SUBJECT: AMENDMENT NO. 38 TO FACILITY OPERATING LICENSE NO. NPF-14,  
SUSQUEHANNA STEAM ELECTRIC STATION, UNIT 1

AMENDMENT NO. 38 TO FACILITY OPERATING LICENSE NO. NPF-14 - SUSQUEHANNA STEAM  
ELECTRIC STATION, UNIT 1

AMENDMENT NO. 38 TO NPF-14

SUSQUEHANNA STEAM ELECTRIC STATION, UNIT 1

BASES FIGURE B 3/4 3-1  
REACTOR VESSEL WATER LEVEL

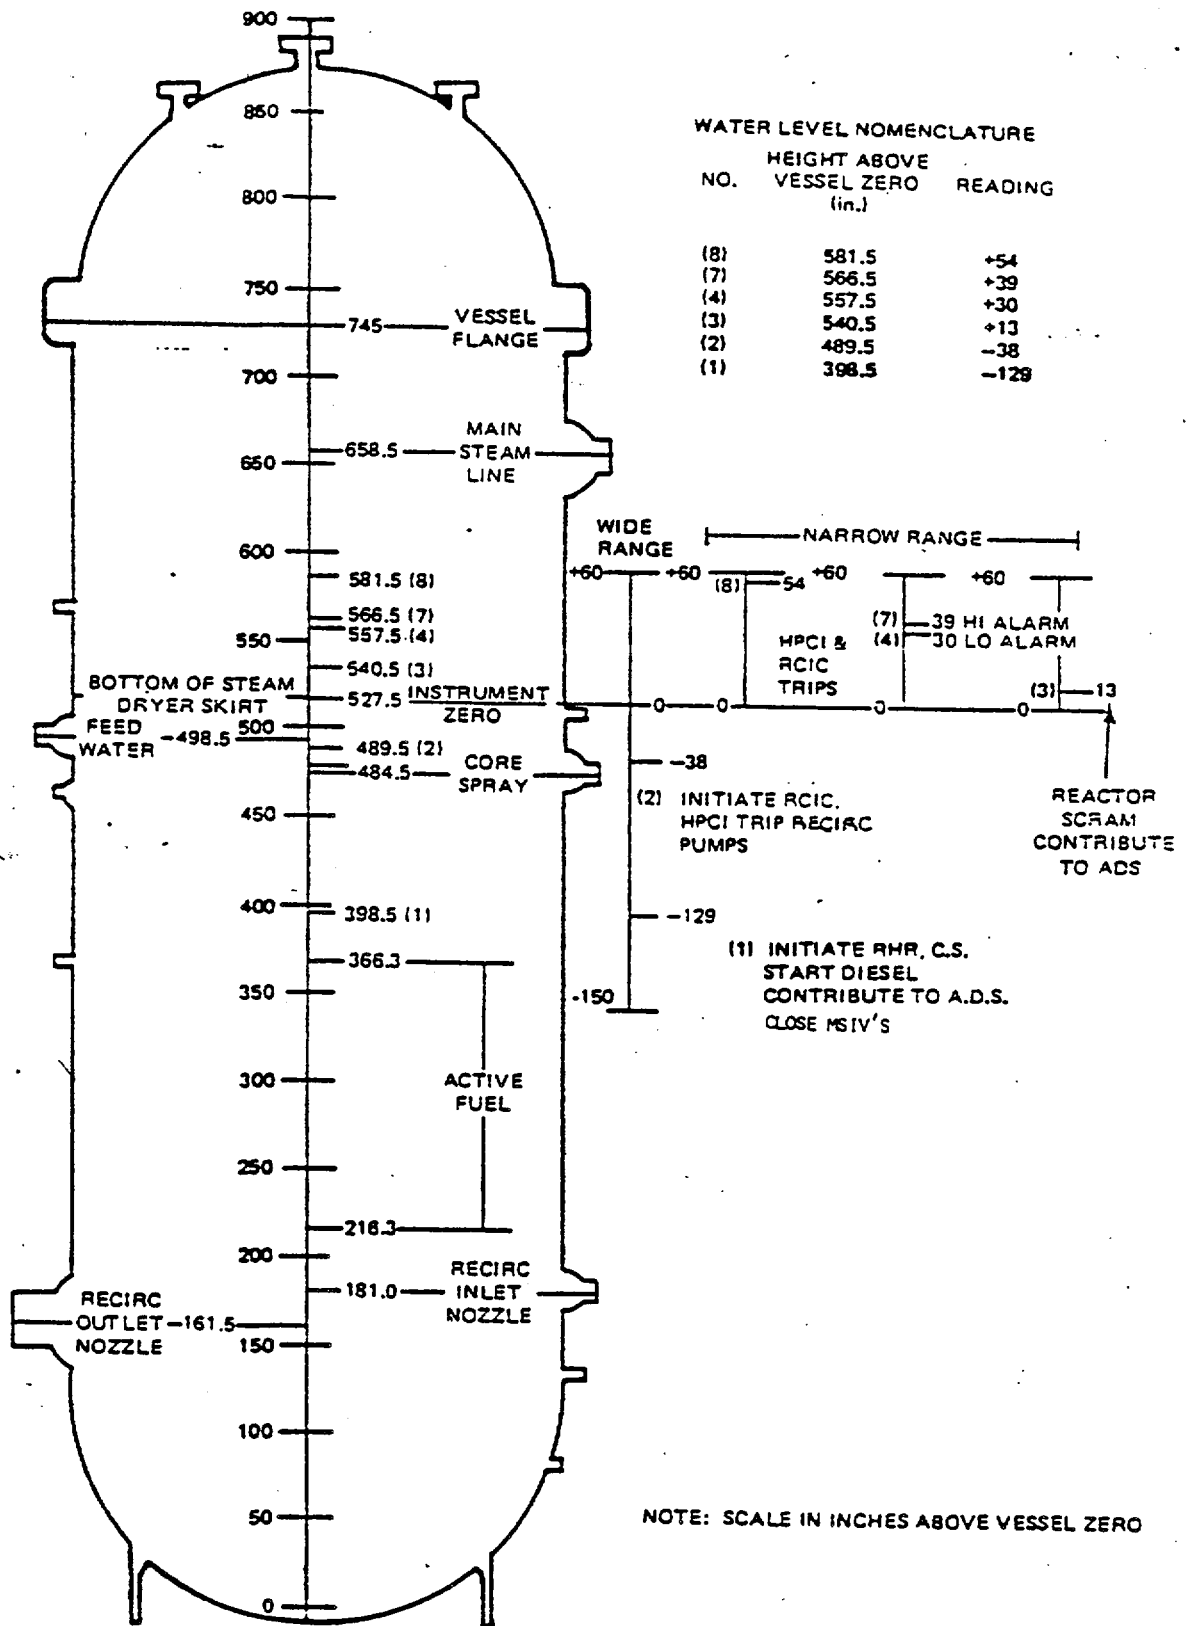
The Nuclear Regulatory Commission has issued the enclosed Amendment No. 38 to Facility Operating License No. NPF-14 for the Susquehanna Steam Electric Station, Unit 1. The amendment is in response to your letter dated October 31, 1984. This amendment revises the Technical Specifications to change the setpoint for main steam isolation valve (MSIV) closure on reactor vessel water low level from Level 2 to Level 1.

The licensee proposed changes to the Technical Specifications of the operating license for Susquehanna Steam Electric Station, Unit 1 to lower the setpoint for main steam isolation valve (MSIV) closure from low water level 2 (Level 2) to low water level 1 (Level 1).

The purpose of lowering the setpoint for MSIV closure is to reduce the number of challenges to the safety-relief valves (SRVs). This modification is consistent with staff recommendations for resolving Action Plan Item II.K.3.16 "Reduction of Challenges and Failures of Relief Valves-Feasibility Study and System Modifications." The licensee reviewed the FSAR transient and accident analyses to assess the impact of the setpoint change on the events. Thermal safety limits for those transients involving MSIV closure on low water level are not affected because the limiting thermal conditions are reached and reduced well before water level falls to Level 2. For loss-of-coolant accidents involving loss of offsite power, MSIV closure will occur on the loss of power signal regardless of water level. For loss-of-coolant accident where offsite power is available, lowering the setpoint will delay closing of the MSIVs. This will result in a more rapid depressurization which leads to earlier injection into the vessel by the low pressure Emergency Core Cooling (ECC) systems.

The proposed modification will eliminate MSIV closures for many transient events where water level falls below Level 2 but is recovered prior to reaching Level 1. This will reduce challenges to the safety-relief valves. As discussed above, previously analyzed transients and accidents are not adversely impacted by the change.
